LONGS RIDGE SUBDIVISION

PRELIMINARY OVERALL AREA DEVELOPMENT PLAN

POADP NUMBER 325

Re: Long Ridge Subdivision POADP # 506

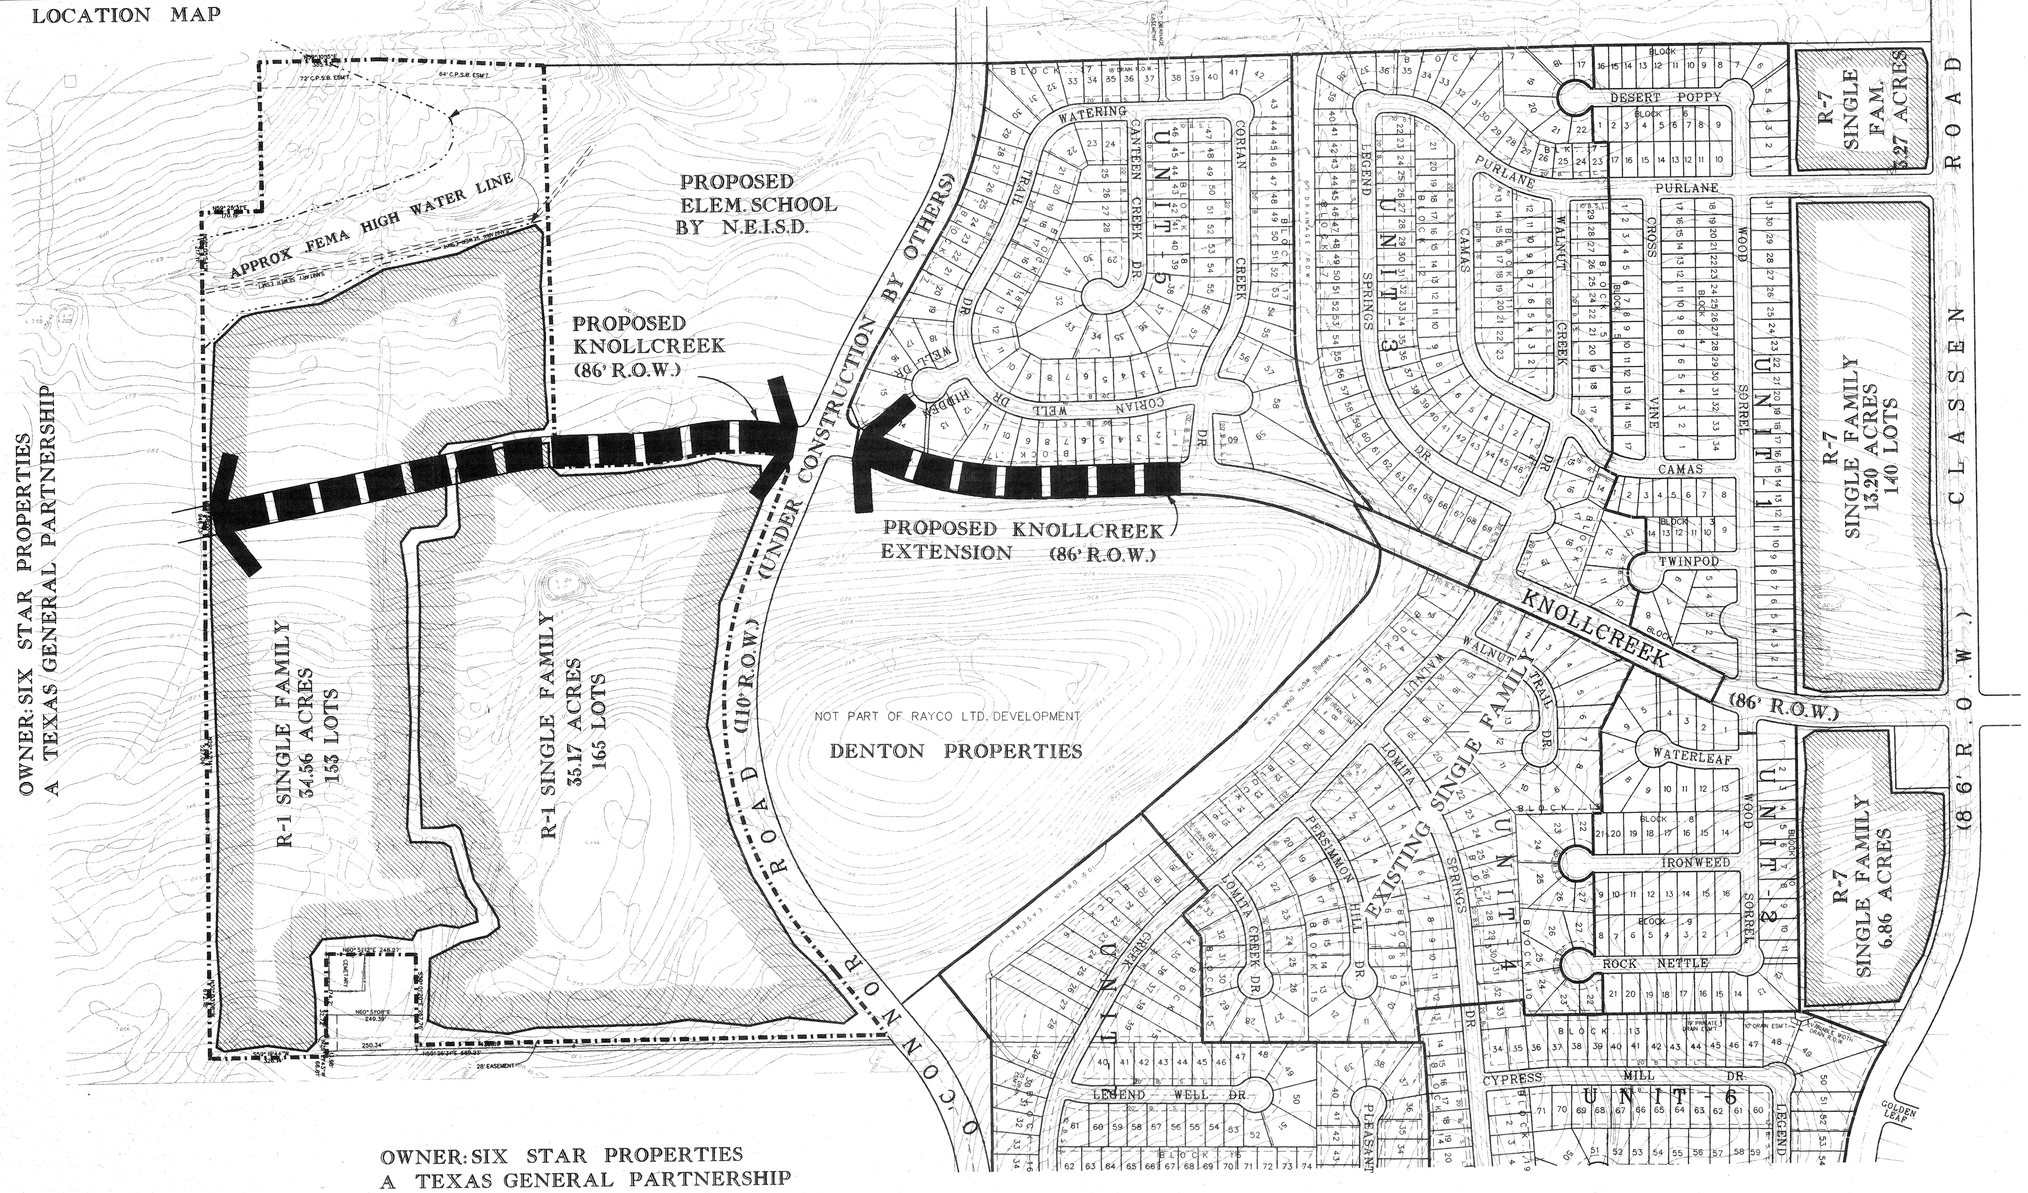
1. Based on the topography, a Flood Plain Study and drainage review will probably be required during the platting process.

2. Staff recommends that there be no residential frontage on the extension of Knollcreek and O'Connor road.

3. We recommend that sidewalk and pedestrian access be provided between the proposed school site and the adjacent property to the east of the proposed school.

Comments: Drainage to be address during the platting process.

A flood plain study will be required during the platting process
